Re: Objection to PLN2020/52

Re: Objection to PLN2020/52

The following document provides strong evidence that the Land Capability Assessment [LCA] within the permit application fails to meet EPA Code of Practice, Best Practice<sup>1</sup> for LCA as well the minimum standards set out in the current Municipal Association of Victoria [MAV] Model LCA 2014<sup>2</sup>. It can be demonstrated that it does however, contain **fabricated and misleading information** in order to prevent the **Land Capability Class Rating** for Land Features and General Site Characteristics from attracting the highest assessed level of constraints for the site **Very Poor (5) Major**.

Fig.1 Permit Appendix.1-Proposed Dwelling Aerial Photo-Dwelling site in red is above mowed track

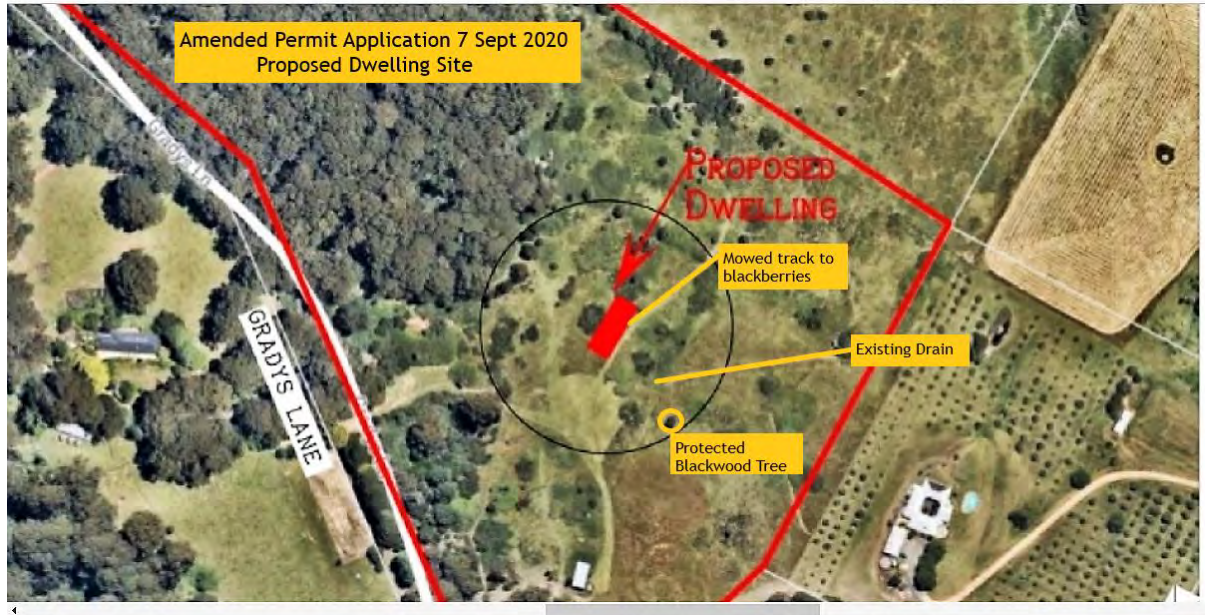
Important to note, *not one* of the Amended Permit plans or aerial photos show the blue DELWP catchment boundary line plus why is dwelling site 10-15m further East in Appendix 9?

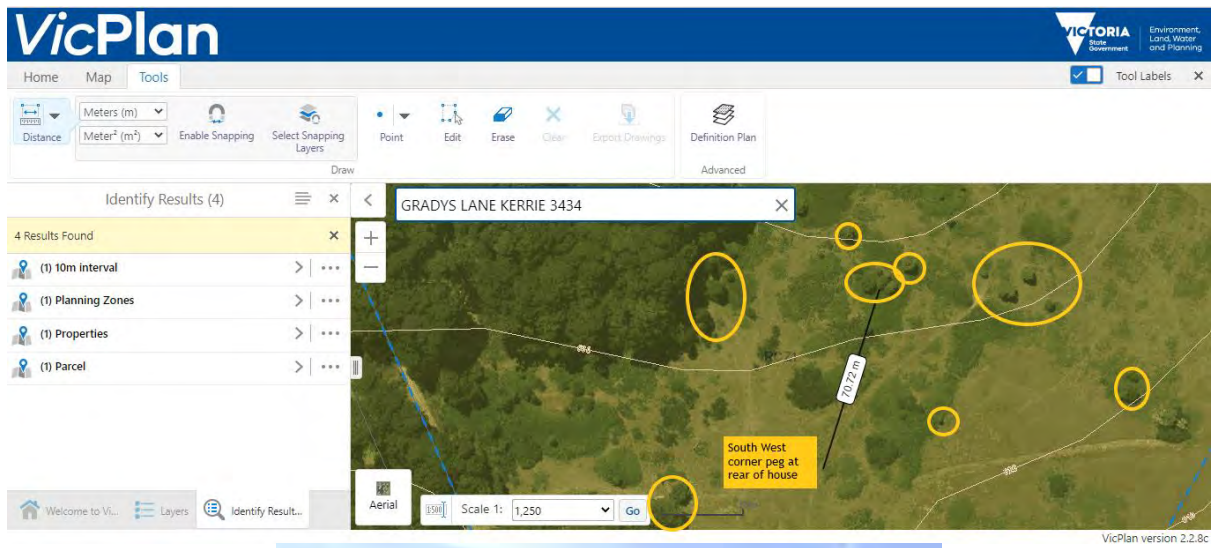
**....no native vegetation impacts will occur**, para.2

*This area supports some occasional scattered native trees and patches, however there is no requirement within the Bushfire Management Plan to modify or clear these remnants*, para.3

BMP Page 2 contradicts Vegetation Report Appendix 11, Defendable Space is a HAZARD
